Shen Zhen Lian Zhong Xin Electronic Co., Ltd.

Original FCC ID: **2A3U8-DC130**; Model Number: **DC130**

New FCC ID: **2A3U8-DC133**; Model Number: **DC133**

This is to advise and officially, that we, **Shen Zhen Lian Zhong Xin Electronic Co., Ltd.** hereby request a change in identification of equipment pursuant to § 2.933.

Original Top	
New Top

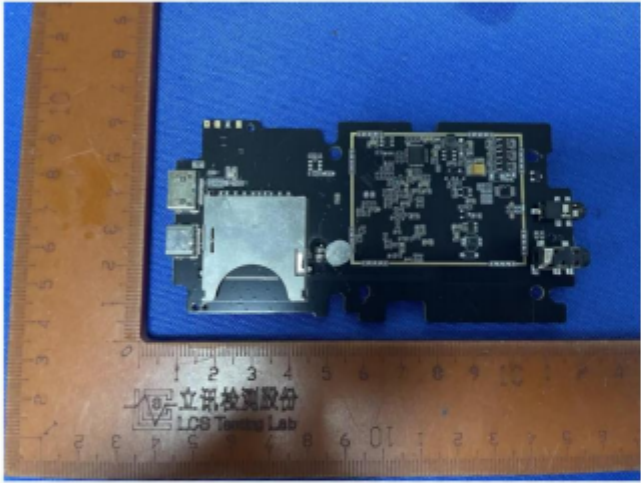
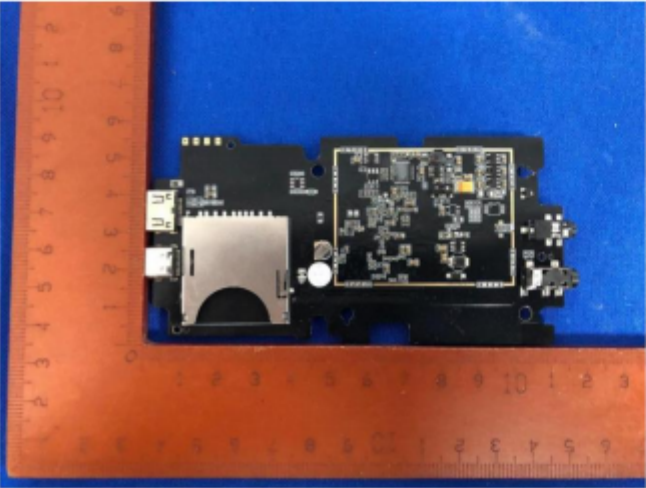
1. Change ID and model number;
 2. The old board capacitor is welded larger, and the new board capacitor is pasted;
- Details as bellows

I attest that such change will not affect 2.4GWIFI Radio section from antenna port (after pre-check, conducted power no higher than original), only effect (AC Power line conducted emissions, Radiated Emissions section of 2.4GWIFI) .
